#### BABCOCK PARK MITIGATION MEASURES

#### Mitigation Measures

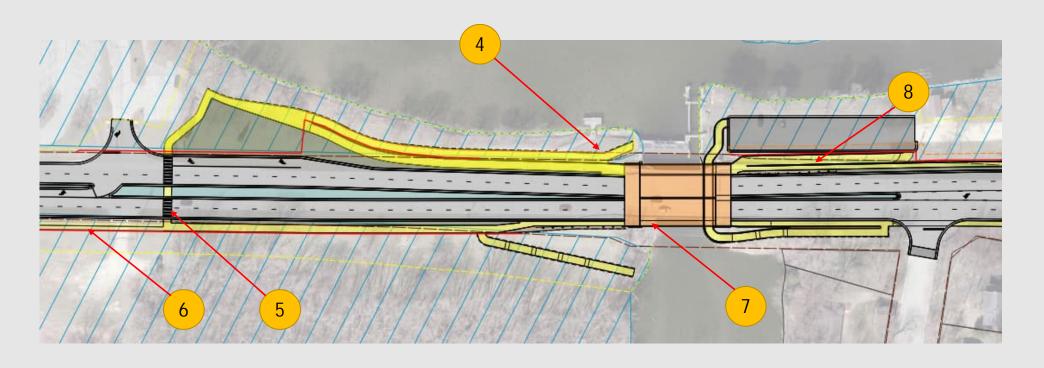
- 4. Access path from proposed US 51 path south of the Yahara River Bridge to the existing boat launch parking lot and dam.
  - Provided for in current design
- 5. Provide crosswalk on US 51 near the overflow parking area on the east side of US 51 to the Yahara River
  - Provided for in current design
- 6. Provide sidewalk from overflow parking area on the east side of US 51 to the Yahara River
  - Provided for in current design

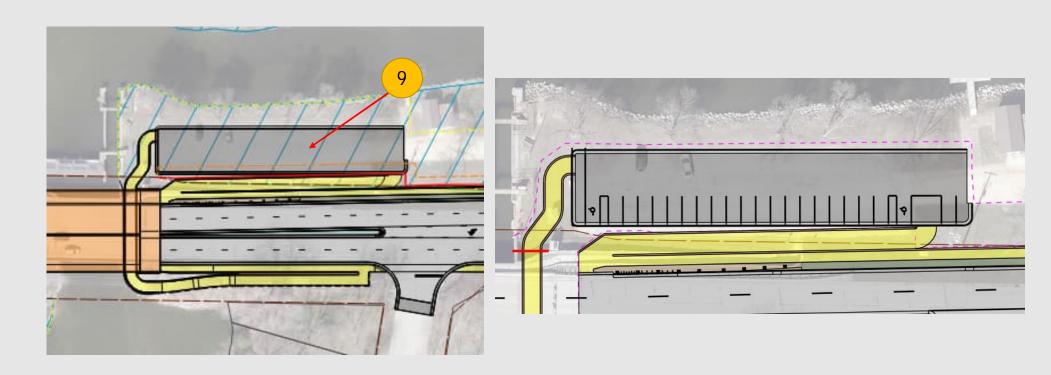
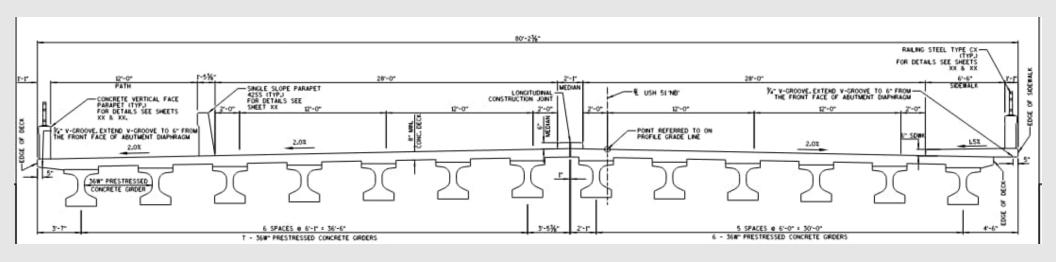
- 7. On the bridge, provide sidewalk on the east side of the Yahara River Bridge and a path on the west side of US 51
  - Provided for in current design
- 8. Provide a connector path from the US 51 path north of the Yahara River Bridge to the parking lot and existing park path on the west side of US 51
  - Provided for in current design
- 9. Reconstruct the dam parking lot as single loaded on the west side and expand the lot north to the existing storage shed
  - Provided for in current design, need further discussion on final layout of the park lot and parking spaces.

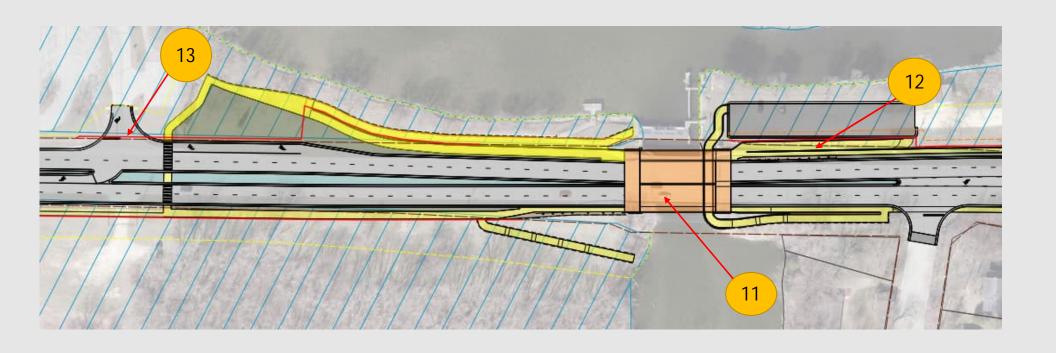
10. Discuss options for entrance drive slope to shower parking lot

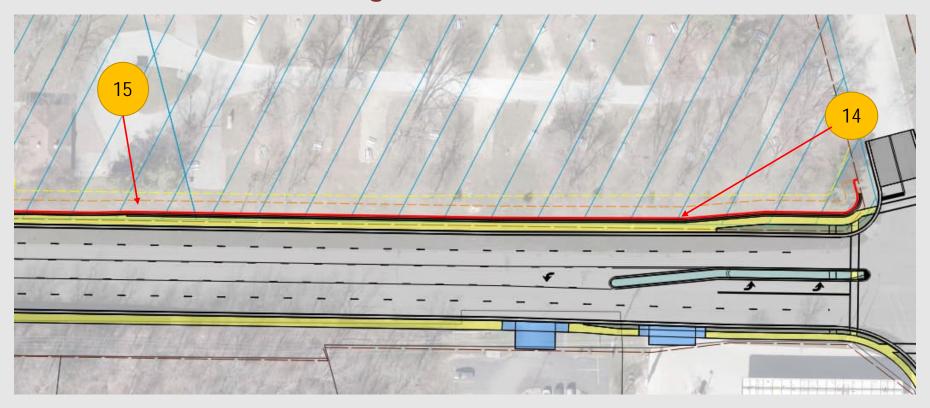
- 11. Lengthen the span of Yahara river bridge to be at least the same as existing dam structure opening
  - Provided for in current design
- 12. Construct retaining wall that includes a transition ramp to provide access to the parking lot
  - Provided for in current design
- 13. Maintain existing boat landing parking lot roadway geometry
  - Provided for in current design

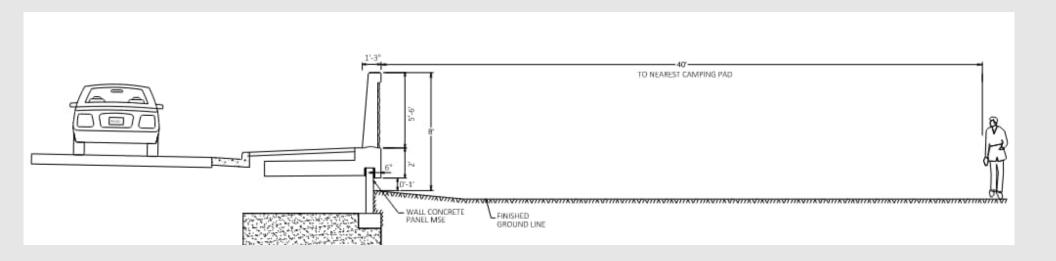
- 14. Provide a screening wall and/or barrier wall from shower building to Burma Road. The wall will be angled at the ends to accommodate signage. Sidewalk will also be provided along this area.
  - Sidewalk is accounted for, discuss wall
- 15. Provide some aesthetic and informational provisions on the screening/barrier wall
  - Discuss

- Considering a barrier wall 8' tall
- Discuss aesthetics for all walls
